REVISED RESPONSE TO REQUEST FOR ADDITIONAL INFORMATION

APR1400 Design Certification

Docket No. 52-046

RAI No.: 182-8160
SRP Section: 03.07.01 – Seismic Design Parameters
Application Section: 3.7.1
Date of RAI Issue: 08/31/2015

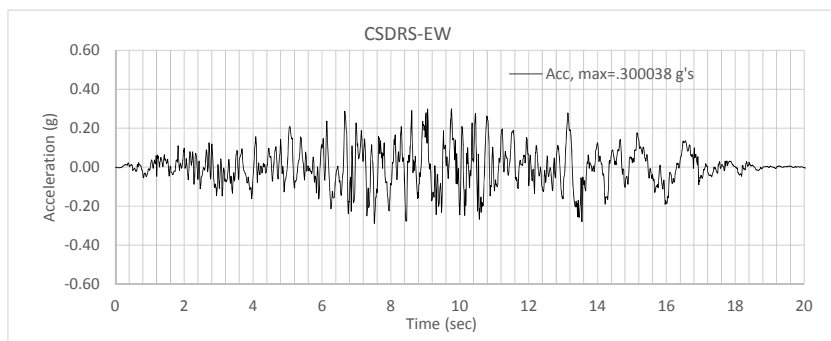
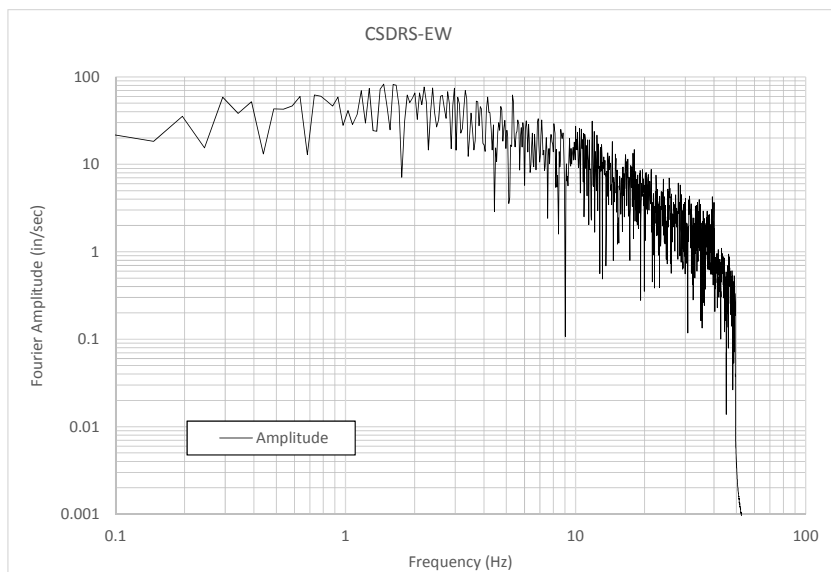
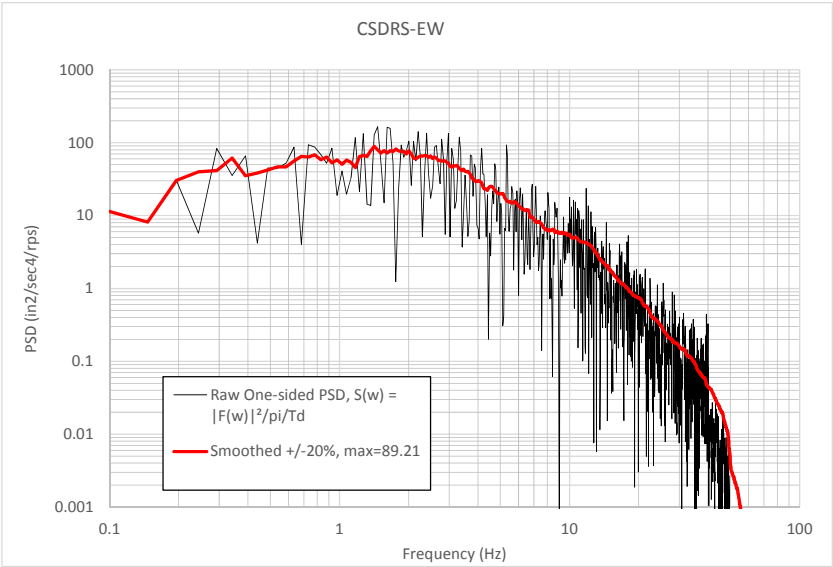
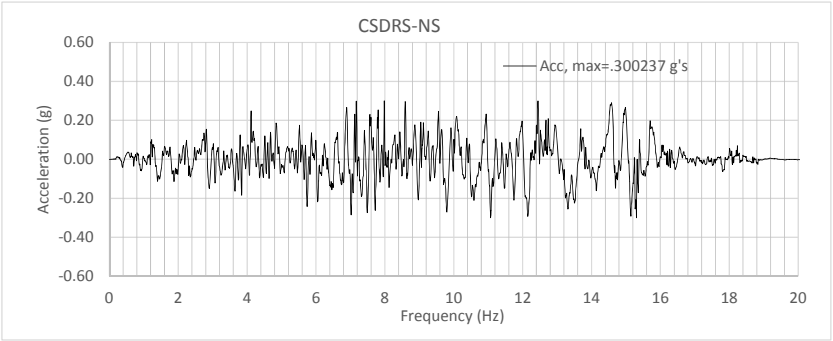
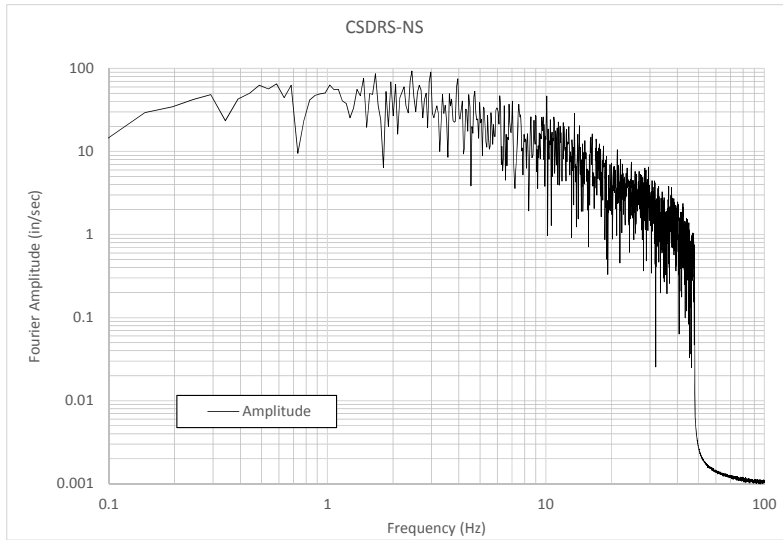
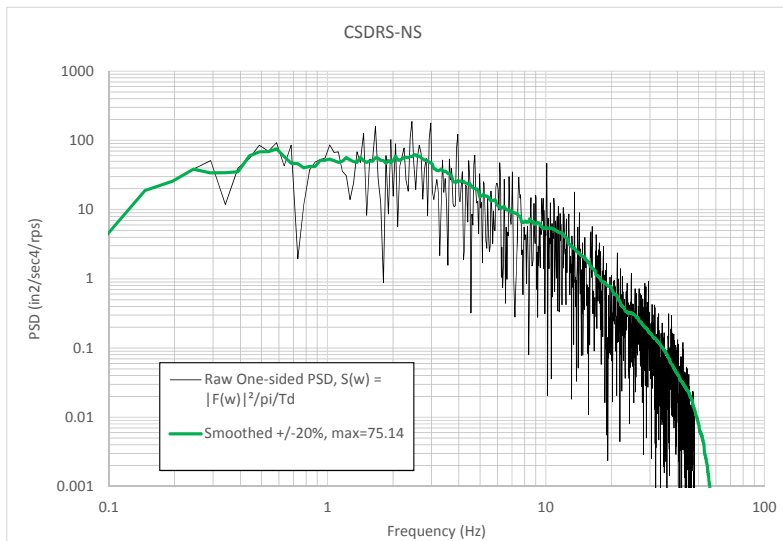
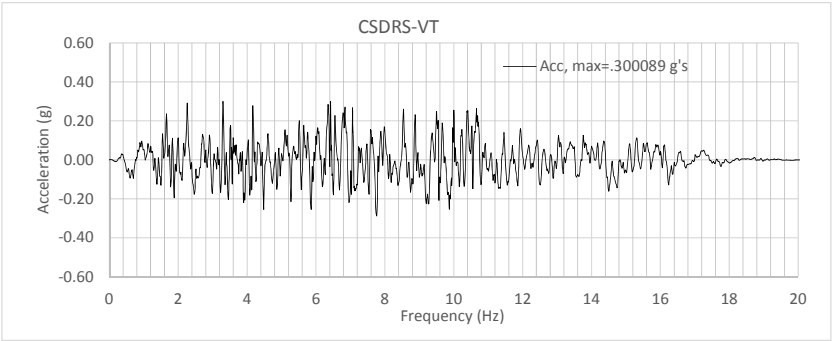
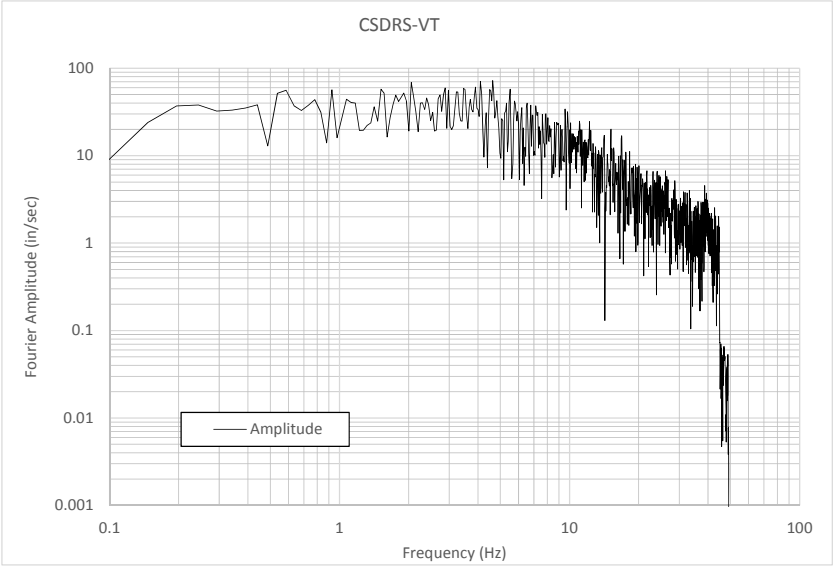
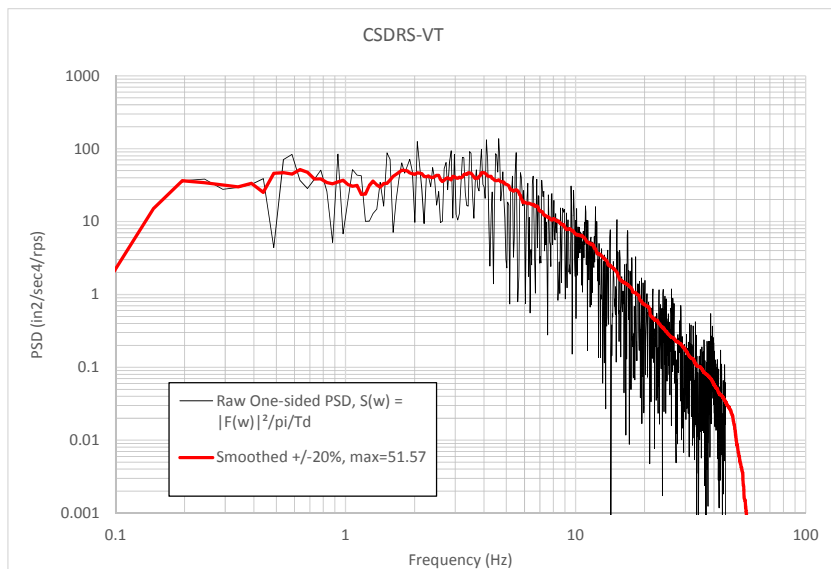
a) Explain the method used to estimate PSD for the CSDRS time histories

In DCD Section 3.7.1.1.2, the PSDs of the design acceleration time histories are compared to the corresponding target PSD. However, the method to estimate the PSD from an acceleration time history is not provided. Therefore, the applicant is requested to provide a description of the method for the PSD estimation and justify any difference of the method as compared to the guidance provided in SRP 3.7.1. The provided information should include the definition of the strong motion duration, portion of the time history used to compute the Fourier spectra, PSD smoothing, and any normalization parameters used in Fourier transform and PSD calculation.

The full time histories are the time histories of full duration from 0 to 20.48 seconds. The 0% to 100% extended equivalent stationary duration designated as $T_{es}(100\%-0\%)$ is computed as $T_{es}(100\%-0\%) = T_{e100\%} - T_{e0\%} = (T_{75\%} - T_{5\%}) / (75\% - 5\%) = T_{(75\%-5\%)} / 0.7$. The time histories, the Fourier amplitudes, PSD and smoothed PSD for time histories of full duration time histories are shown in Figures 1 through 9, respectively.

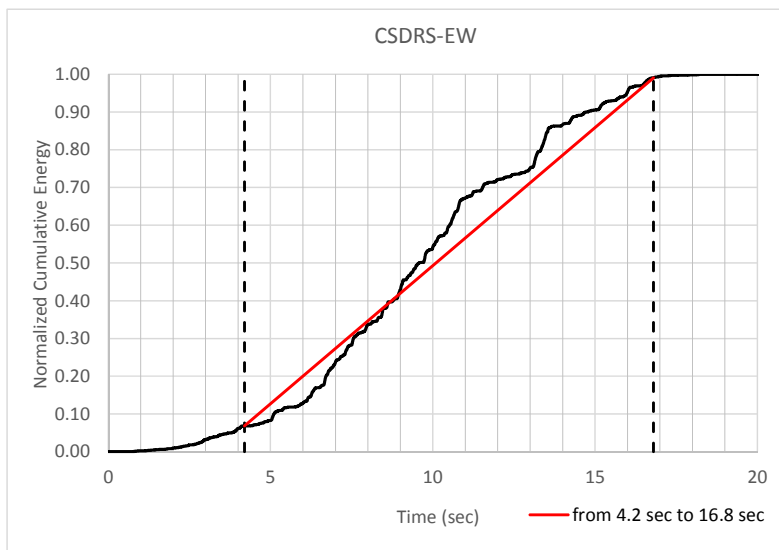
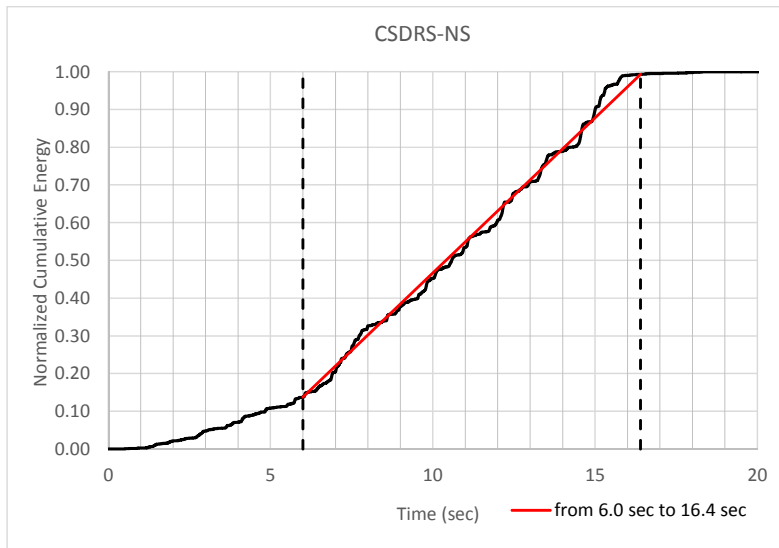
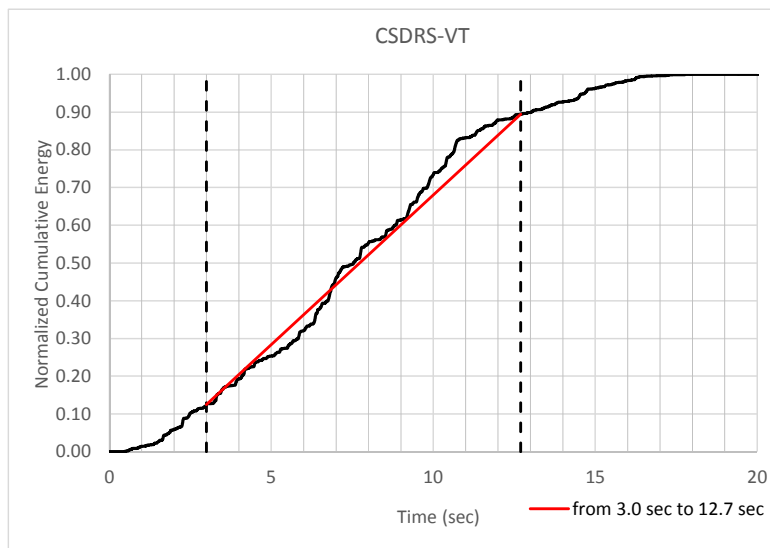
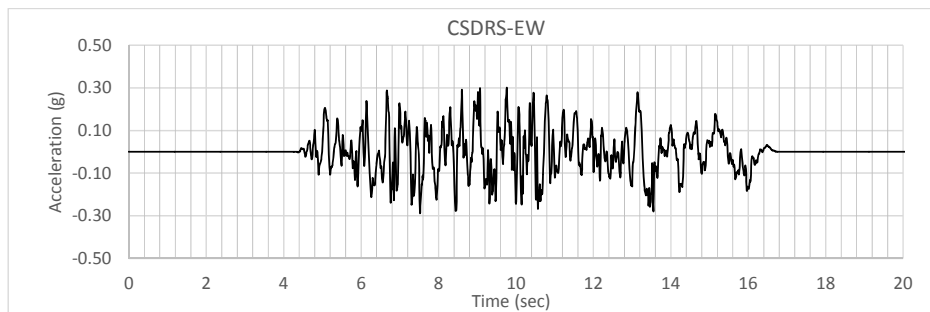
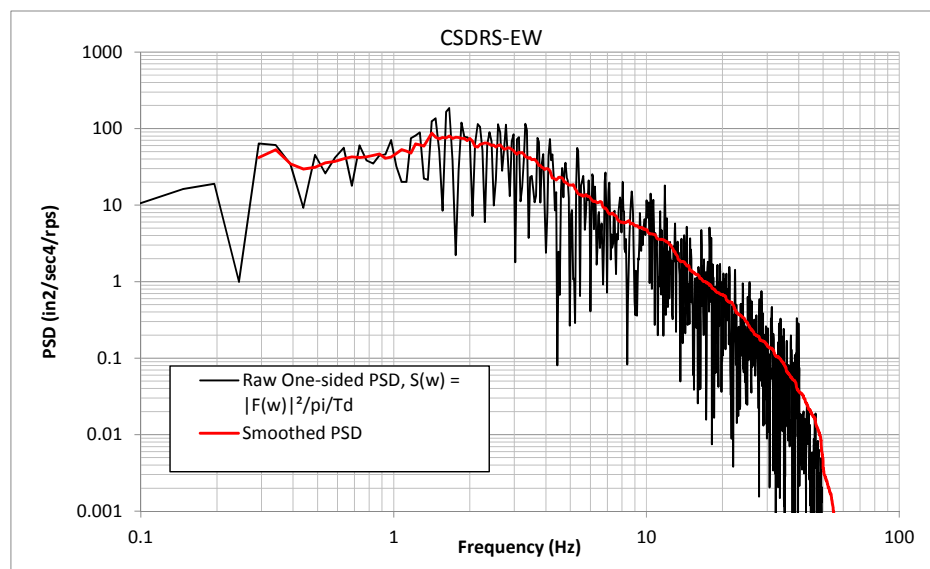
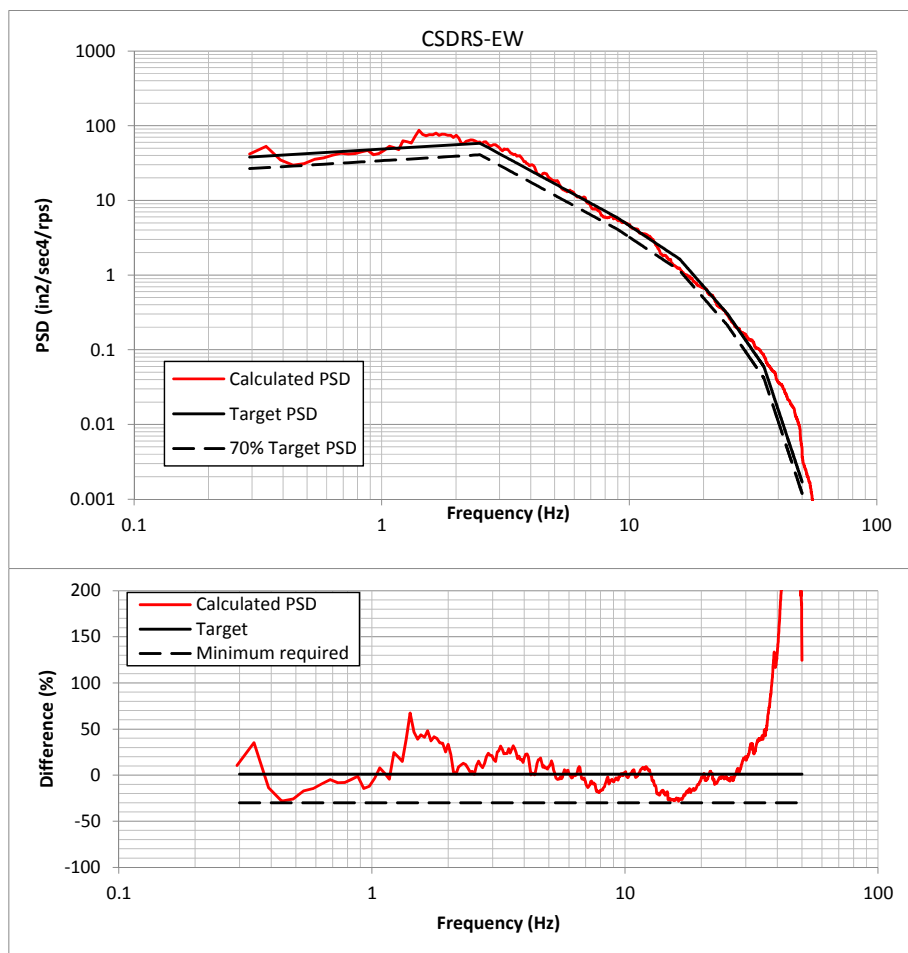
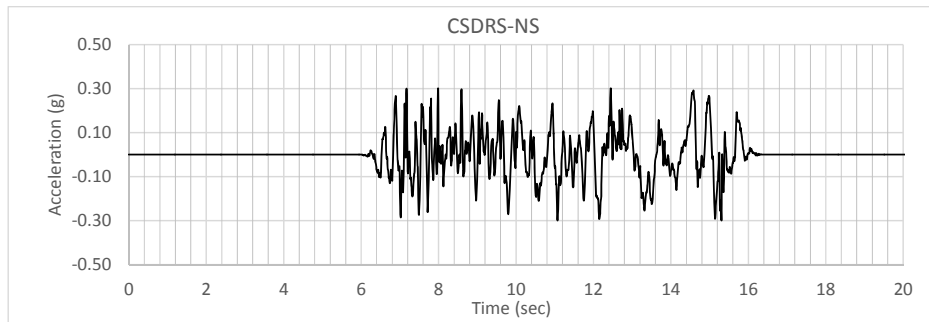
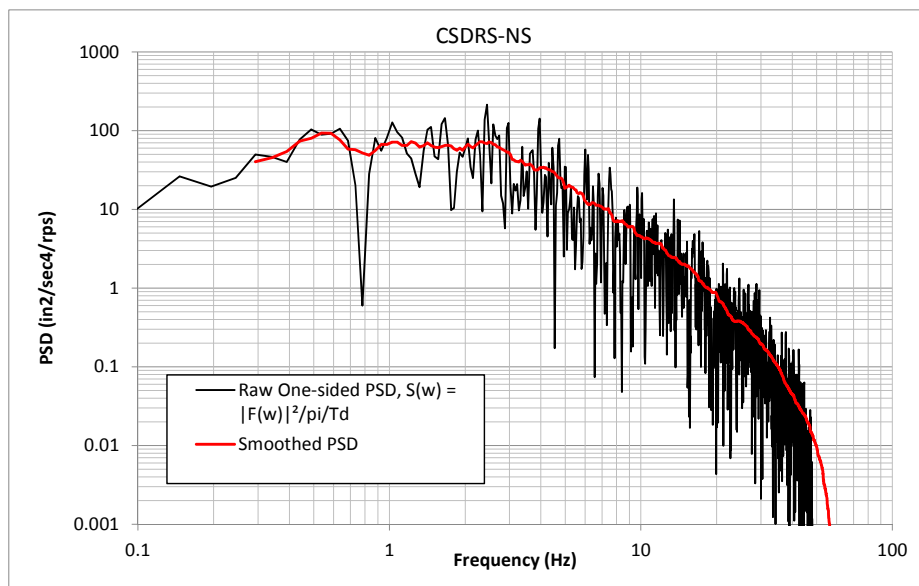
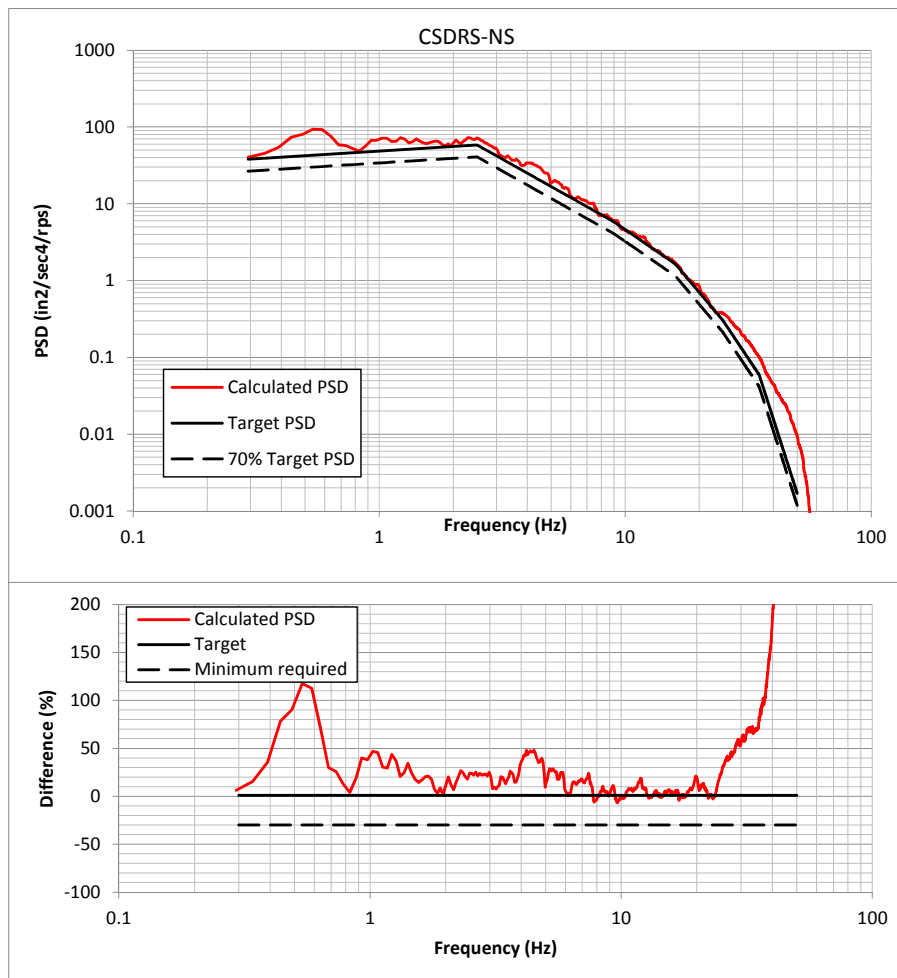
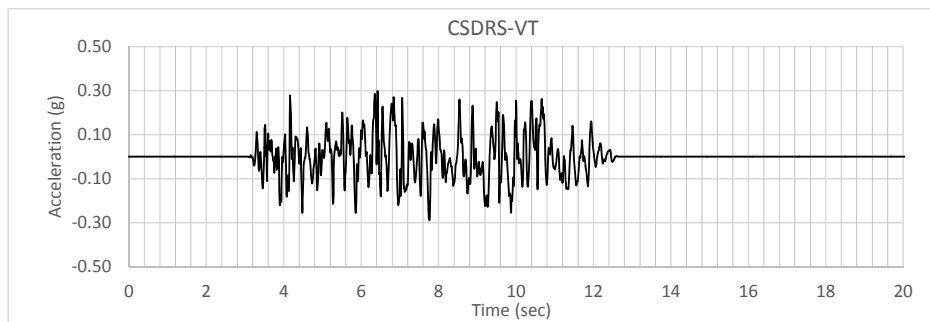
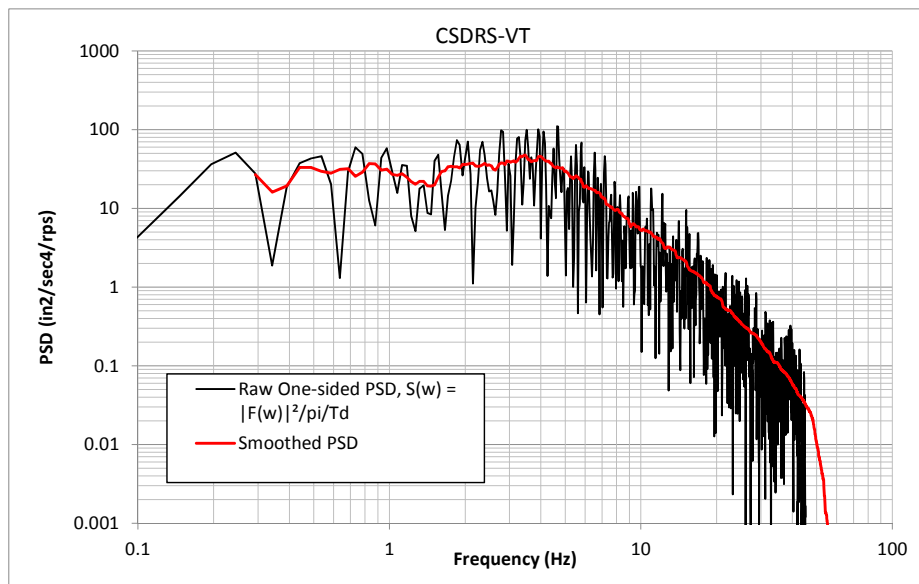
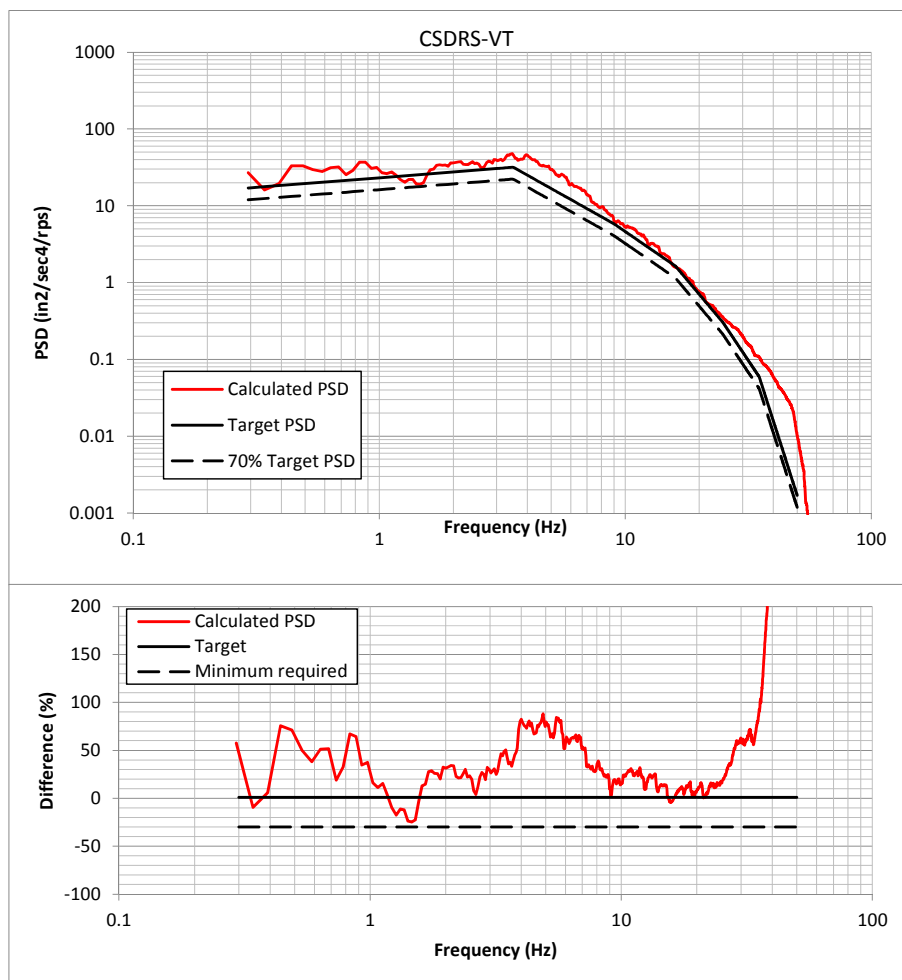
Appendices A and B of SRP 3.7.1 indicate that PSD should be estimated based on the strong motion duration. Therefore, the staff requests that the applicant provide a justification for the use of equivalent stationary strong-motion duration. Similarly, the applicant is requested to explain why the entire time histories were used in the Fourier transform. The use of the equivalent stationary strong-motion duration, which is shorter than the entire duration as shown in Figure 3-27 of APR1400-E-S-NR-14004-P, Rev. 1, together with the entire time history used in the Fourier transform, may overestimate the PSD for those frequencies that have very low magnitude but span the entire time history

The PSDs for time histories of truncated duration are computed in accordance with Appendix B of SRP 3.7.1, Rev. 4. The strong motion durations for the CSDRS compatible time histories are defined as shown in Figures 10 through 12. Using the truncated time histories and the corresponding the strong motion duration, the PSDs for the CSDRS compatible time histories are computed as shown in Figures 13 through 21. The PSDs for the CSDRS compatible time histories envelop 70% of target PSD as

shown in Figures 15, 18, and 21. Thus, the PSDs for the CSDRS compatible time histories satisfy the requirement of Appendix B of SRP 3.7.1, Rev. 4.
